OFFICIAL COORDINATION REQUEST FOR NON-ROUTINE OPERATIONS AND MAINTENANCE

COORDINATION TITLE – 15 LWG 025 Lower Granite JBS Primary Outfall Construction

COORDINATION DATE – 15 December 2015, follow-on clarifications 08 February 2016; Revised 13 April 2016; Revised 27 May 2016

PROJECT – Lower Granite Lock and Dam

Figure 3. Typical fall Chinook spawning area in the Lower Granite Dam tailrace and new outfall construction area. The bright red line represents the new primary bypass outfall. The orange line represents the new emergency bypass outfall.

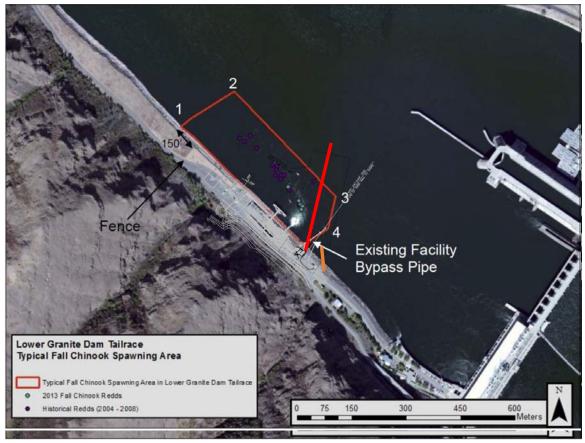
A known fall Chinook spawning area will be disturbed as part of constructing the new primary bypass outfall structure during this time period. It is possible that 5-10 fall chinook redds may be disturbed based on historical survey efforts (Figure 3). The shutdown of the JBS in August will reduce the likelihood of fall Chinook spawning in the area due to no water discharge from the JBS during the spawning period. As discussed at the 28 May 2015 NWW FFDRWG meeting, no new spawning surveys will be conducted as part of constructing the new primary or emergency bypass outfall.

The potential to disturb fall Chinook redds during in-water construction activities was discussed at NWW FFDRWG at the 28 May 2015 meeting. All participating fish managers including NOAA agreed to proceed with bypass outfall construction activities during the 2016/17 in-water work window without conducting additional spawning surveys or modifications to the new primary bypass outfall footprint.

s discussed at FFDRWG and FPOM and documented in the FPOM MOC, no additional redd surveys will be conducted as it is understood that there is some potential to disturb fall chinook spawning regardless of year the construction is completed and that potential for spawning in the tailrace will be reduced during the upcoming extended JBS outage (1 Aug 2016 to 24 March 2017) as there will be no water discharge from the JBS in the vicinity of historical spawning areas.
